LEE'S SUMMIT
MISSOURI
Development Services Department

Development Services Staff Report

File Number	PL2023-151
File Name	PRELIMINARY DEVELOPMENT PLAN – Streets of West Pryor, Lots 11 and 13
Applicant	Streets of West Pryor, LLC, applicant
Property Address/Location	1000 and 1020 NW Pryor Rd.
Planning Commission Date Heard by	August 24, 2023 Planning Commission and City Council
Analyst	Hector Soto, Jr., AICP, Senior Planner

Figure 4 - Partial north building elevation.

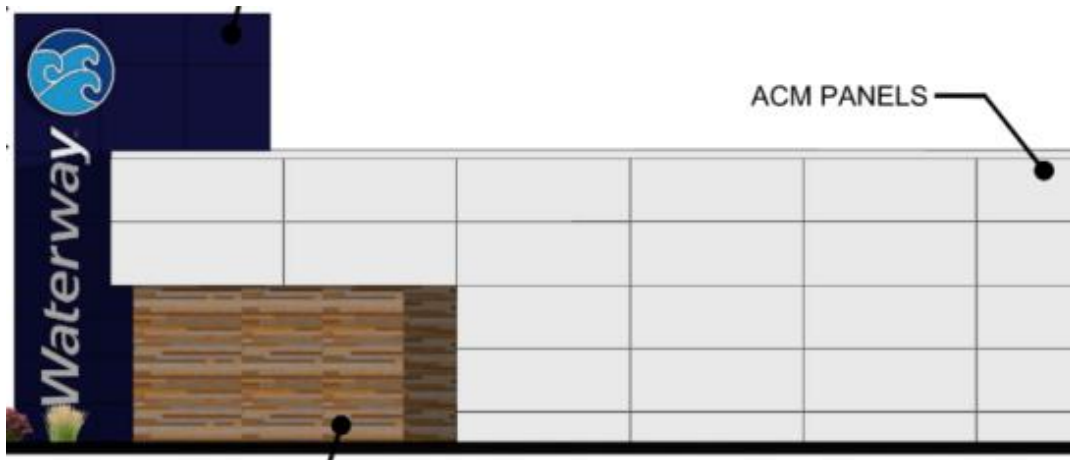
¹ – A projecting vertical architectural feature is proposed on the east building elevation. Signs are proposed to be installed on the north- and south-facing sides of said architectural feature. Because the north-facing side of the architectural feature is off-set less than 5’ from the north façade of the building itself, the north-facing side of the architectural feature is considered a continuation of the north building façade for sign area calculation purposes. As a result, the sign on the north side of the architectural feature is calculated to constitute 4.3% of the combined north building and architectural feature façade.

- The gas pump island canopy elevations depict signage on all four elevations with sign area from approximately 12% to 12.3%, exceeding the 10% sign area allowance.
- The south face of the vertical architectural feature projecting from the east façade of the tunnel carwash building has signage that constitutes approximately 51.1% of said feature.

- The gas pump island canopy shall be limited to no more than 10% sign area in accordance with the sign ordinance.
- As previously described, the applicant proposes signage of similar size on both the north- and south-facing sides of the vertical architectural feature projecting from the east building façade. Although the double-faced vertical architectural is of identical size and appearance on both sides, the area of signage allowed on each face is calculated differently due to the difference in how far the faces of the architectural feature are located relative to the north and south building façades. Because the south-facing side of the architectural feature is off-set greater than 5' (approximately 56'-6") from the south façade of the building itself, the south-facing side of the architectural feature is considered its own distinct south façade for sign area calculation purposes. As a result, the sign on the south face of the architectural feature is calculated to constitute 51.1% of the south architectural feature façade. However, staff believes the proposed signage on the south-facing side of the architectural feature be to reasonable because it mirrors signage on the opposite side of the same feature, which is found to be compliant only for the fact that the north façade is less than 5' from the north building façade and therefore is considered an extension of said north façade.

2. A maximum of four (4) wall signs shall be allowed on both the carwash tunnel building and gas pump island canopy on Lot 11. Signage shall comply with all other sign standards (e.g. maximum allowable sign letter height, sign area, etc.) of the PMIX zoning district, except that the wall sign on the south-facing architectural feature located on the east carwash building façade shall be allowed a maximum 51.1% sign area as depicted on the building elevations dated August 17, 2023.
3. A maximum of three (3) wall signs shall be allowed on the two endcap tenant spaces for the multi-tenant building on Lot 13. Signage shall comply with all other sign standards (e.g. maximum allowable sign letter height, sign area, etc.) of the PMIX zoning district.

Figure 9 - West building elevation.

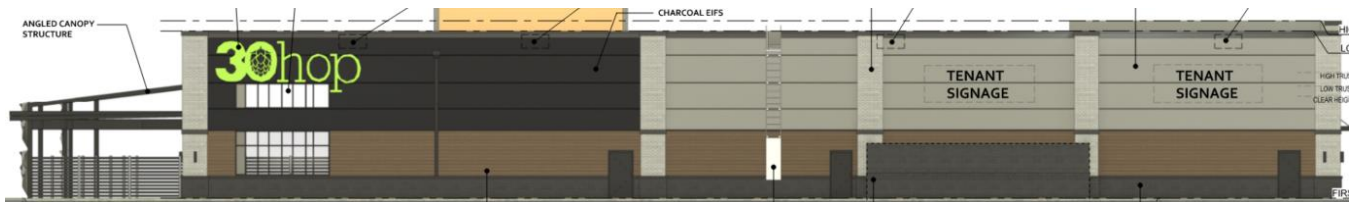
- A total of three (3) wall signs are proposed for each of the endcap tenant spaces.

- **Recommendation** – Staff has historically viewed the allowance of three (3) walls signs for endcap spaces on a multi-tenant building to be a reasonable request given the number of tenant space façade exposures. In an effort to support the goals and intent of the City’s sign ordinance to reduce visual clutter; enhance and protect the physical appearance of the city; and to create a more attractive economic and business climate, staff recommends that each multi-tenant building endcap space on Lot 13 be allowed a total of three (3) wall signs.
